Addendum 1

Date: 10/14/22

Addendum 1 Items:

Refer to Drawing E409:

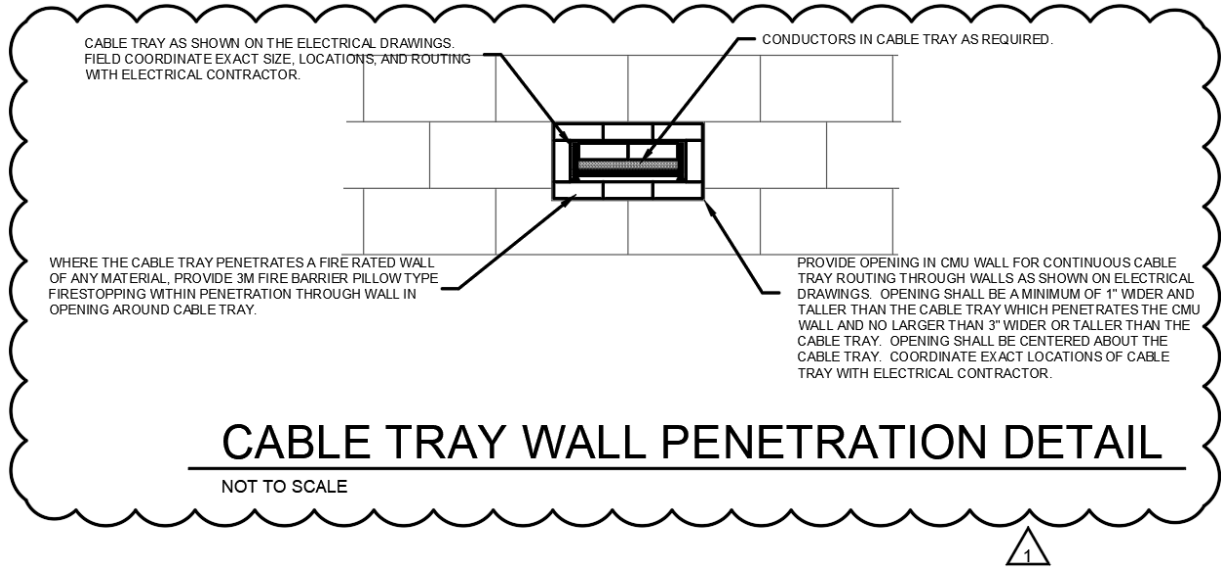
1. Add 20 amp, 120 volt circuit originating from Panel ES1AL-27 to serve the Building Automation System (BAS) Control Panel on the South wall of Room 123 near Column Line 126. Provide 20 amp single pole snap switch to serve as disconnect switch at the BAS control panel.
2. Add circuits and disconnect switches for electric heaters EH105A and EH 105B.

Refer to Drawing E601:

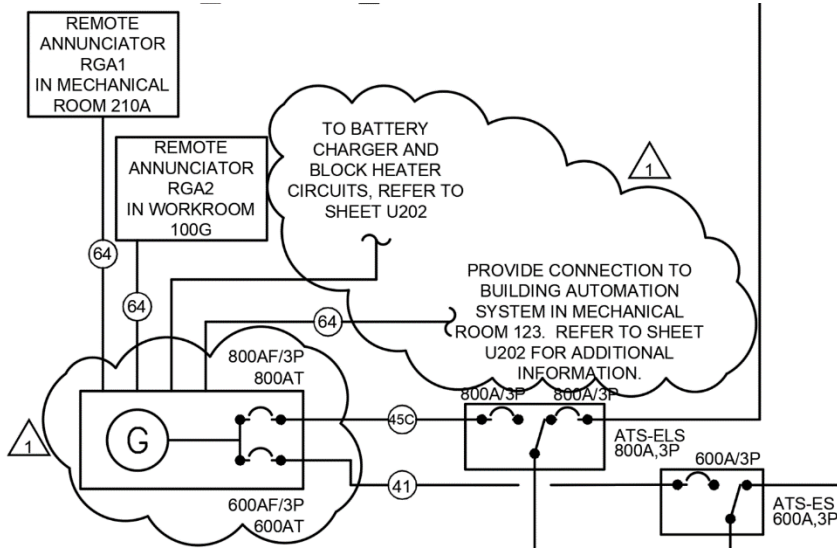
1. Clarification: The emergency generator with dual output circuit breakers printed incorrectly in light line weight; change the emergency generator with dual output circuit breakers to heavy line weight. The emergency generator with dual output circuit breakers is to be New and included in this project.
2. Change notes referring to connections to the Generator as follows:
